## **DESIGN AND ACCESS STATEMENT**

Demolition of existing rear extension, basement proposal and rear extension

20a Ferncroft Avenue, London, NW3 7PH

November 2019

FIG.2 PRE-PLANNING SUBMISSION EXCAVATION LEVEL

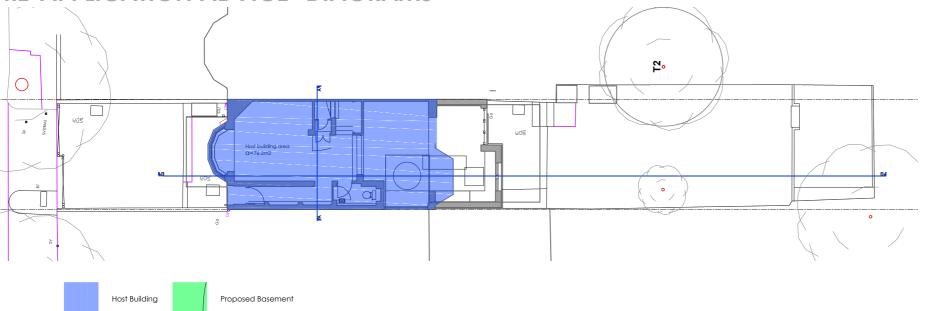
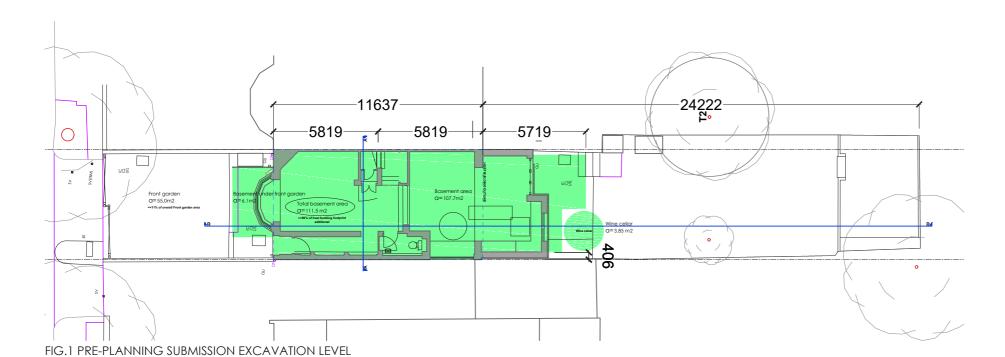
- 2.11. It is evident from the proposed section that the rear portion of the extension would step down from the level of the main kitchen. This has three key impacts: 1. It increases the minimum depth of excavation for the basement necessary to achieve acceptable floor-ceiling height at basement level. 2. It results in an overly dominant ground floor rear elevation which accounts for almost 50% of the height of the pitched-roof building. 3. It results in the need for greater excavation of the rear garden area from its existing levels, which may have consequences for the character of the rear garden and trees.

- 2.12. You are advised to remove the additional step down at the rear portion of the extension in order to minimise its impact, so that the development provides a more balanced rear composition and requires less excavation. For the reasons set out above the scale and design approach of the rear elevation of the ground floor extension is not acceptable as currently proposed.

Further to the pre application advice, the level difference between the existing kitchen and the rear extension has been reduced from 828mm to 580mm. This reduces the excavation required whilst still allowing daylight to reach the lower levels. Excavation reduction is illustrated in Fig.2 & Fig.3 on page 7 of this D&A.
